Kōrero mai | Let's talk

Cashmere-Penruddock intersection upgrade submissions, January 2026

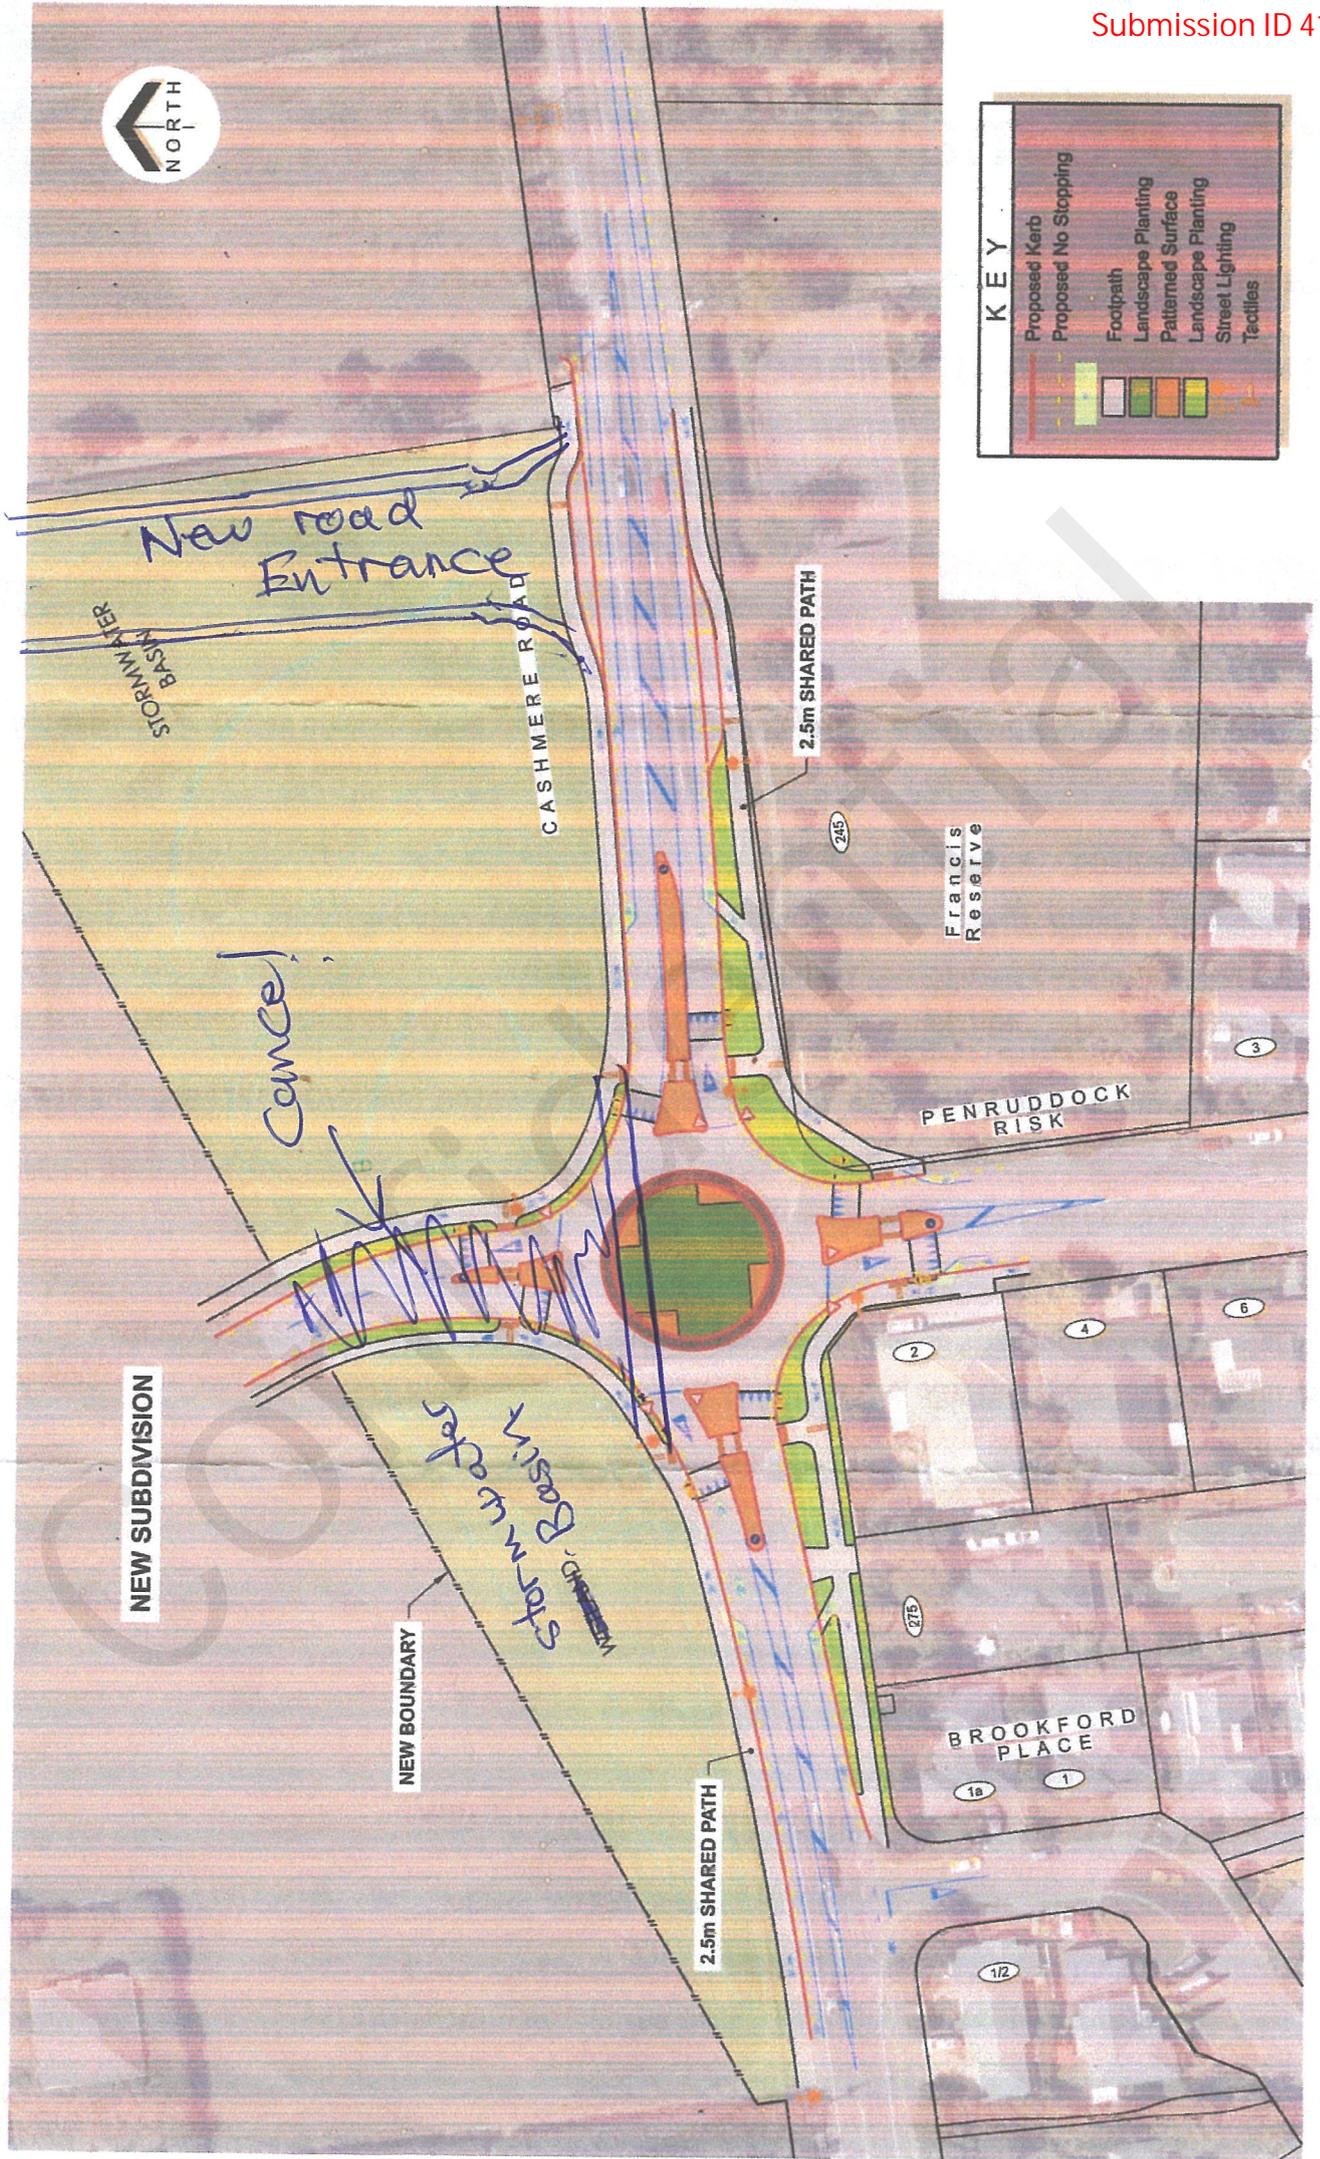
Submission to Letstalk
Cashmere Road and
 Penruddock Rise intersection
From Landowner next to
 the subdivision David Lee,
Date 22-01-2026.

- ① Round about :- No
 traffic Lights :- Yes.
- ② Reason why! Example
 Henderson Road / Sparks Road
 was a Round about now change
 To traffic Lights.
- ③ Traffic Lights if for the future,
 it allow for Auto drive future
 vehicle.
- ④ Traffic Light makes it easier
 for older Driver, why! roundabout
 you have to judge distance
 and with old driver on the road
 it not that easy.
- ⑤ Traffic Light is better for
 Heavy Truck and Tractors.
- ⑥ Traffic Lights is better for Cyclist
 eg, Training cyclists that ride
 at speed over 40 km/hr,
 Group cyclists and pension cyclists
- ⑦ Alternative is shift the Entrance
 to East side of subdivision.
 therefore no need for Round about
 or traffic Light. refer to attach
 other plan.
